SYSTEM/MODEL: LEF

MODIFICATION: Adding selective contact terminals ("K" terminals) to LEF-3/3C

ADDING SELECTIVE CONTACT TERMINALS (LEF-3)
(For use with Video Door Stations)

LEF-3 Schematic Diagram

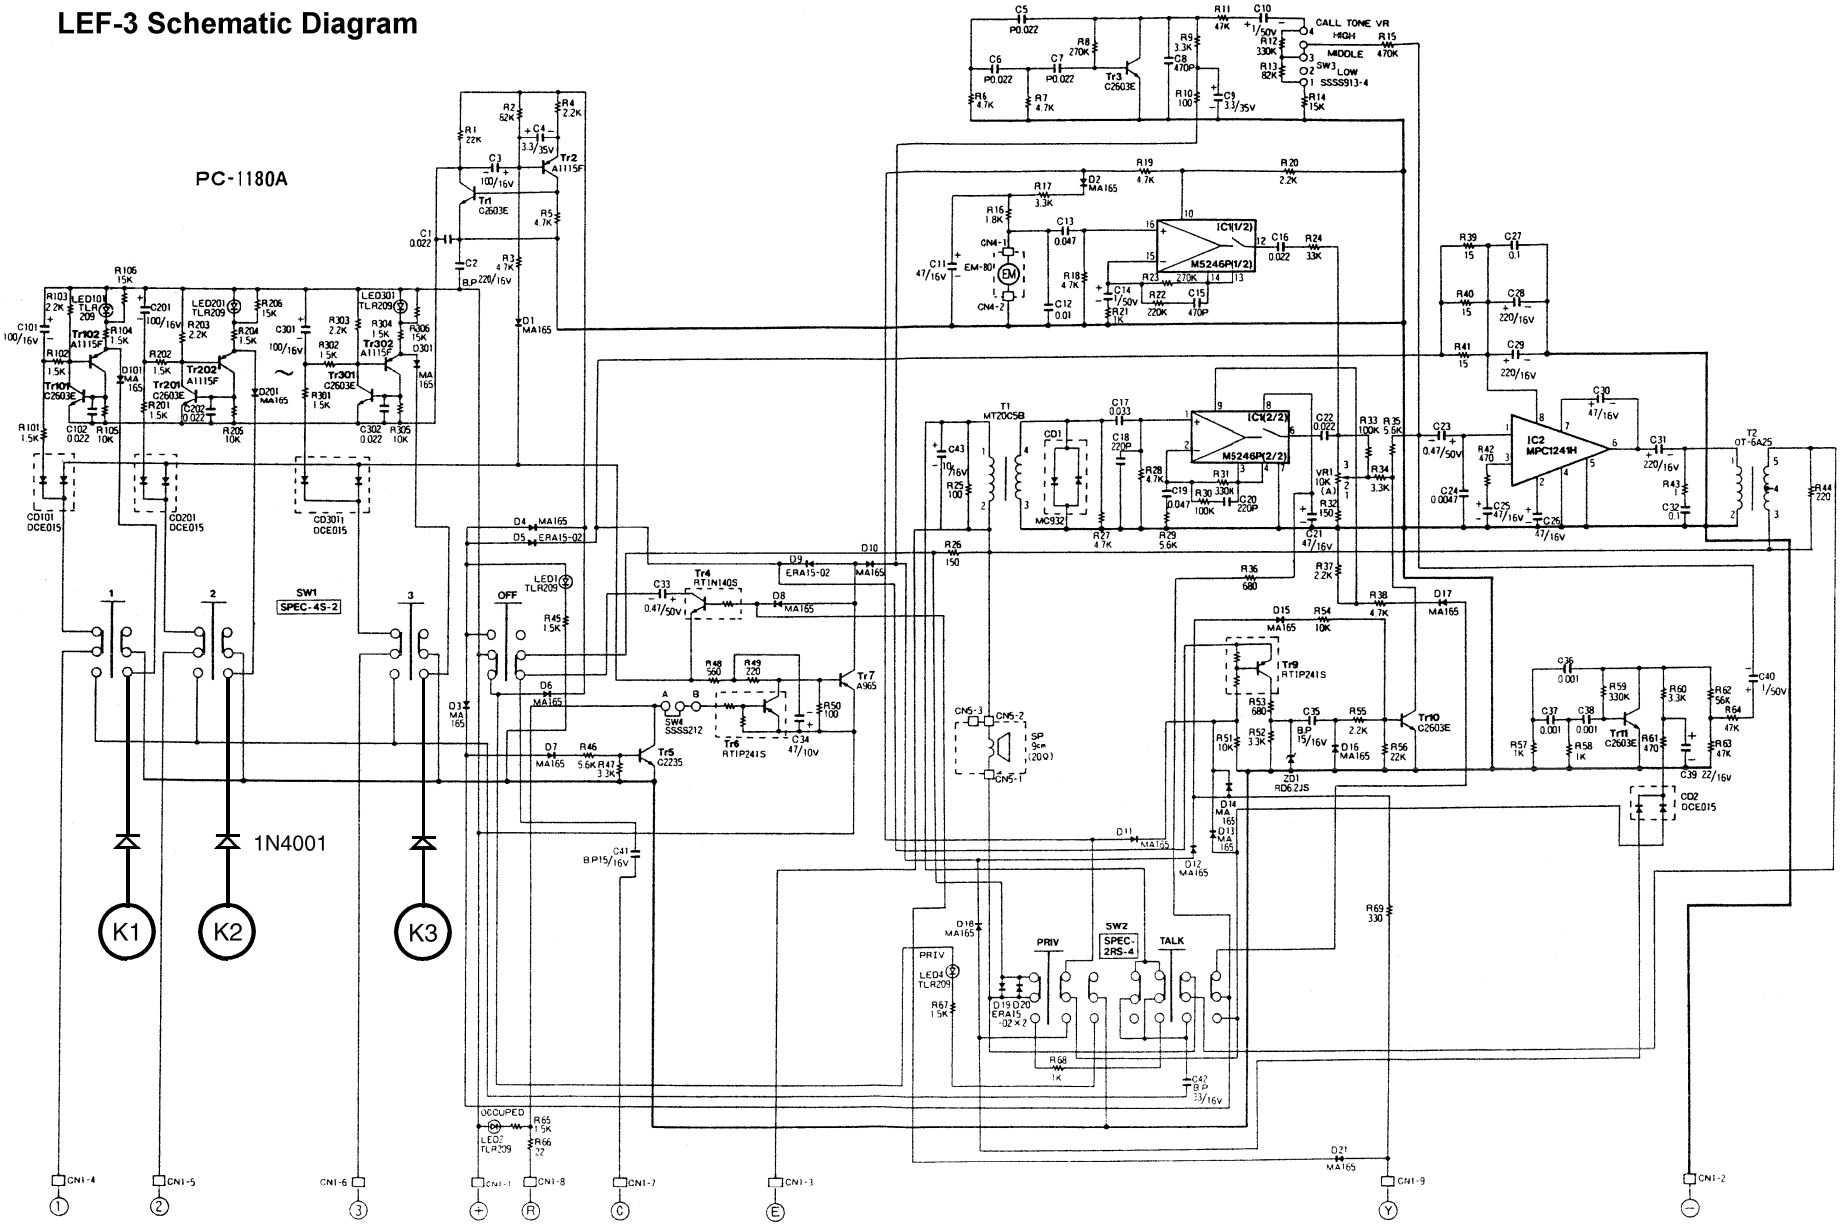
1. Solder diode onto point of station selector switch as shown on schematic diagram. (Cathode side to switch)

2. Solder lead wire to anode side of diode. This additional wire will be the selective negative used to turn on the video door station when the channel is selected.

Add diode (1N4001) as shown, corresponding to the stations that are used to communicate with video door stations.
